# Access Compliance Report Public Rights-of-Way (RR Crossings)

Intersection ID: 10040203	Main Street: TYVOLA_RD	Location: N/A
ADA ID: F5E00E3D62E5	Overall Compliance: No	Severity Score: 0.0
Codes/Mitigation Info/Possible Solution		Field Measurements/Component Compliance

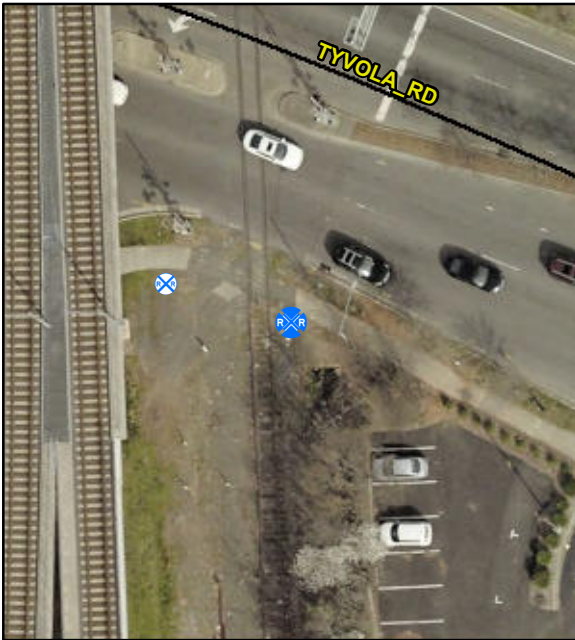
**Install Detectable Warning System.  
Provide Pedestrian Gate. Remove &  
Replace Walking Surface Adjacent  
to Rail.**

Compliance	Description	Data
No	DWS Provided?	No
N/A	DWS Contrast?	N/A
N/A	DWS Width (in)	N/A
N/A	DWS Length (in)	N/A
N/A	DWS Offset (in)	N/A
No	Pedestrian Gate?	No
N/A	DWS Outside Gate?	N/A
N/A	Rail Type?	Freight
No	Flangeway Gap (in)	3.0
Yes	Sidewalk Width (in)	71.0
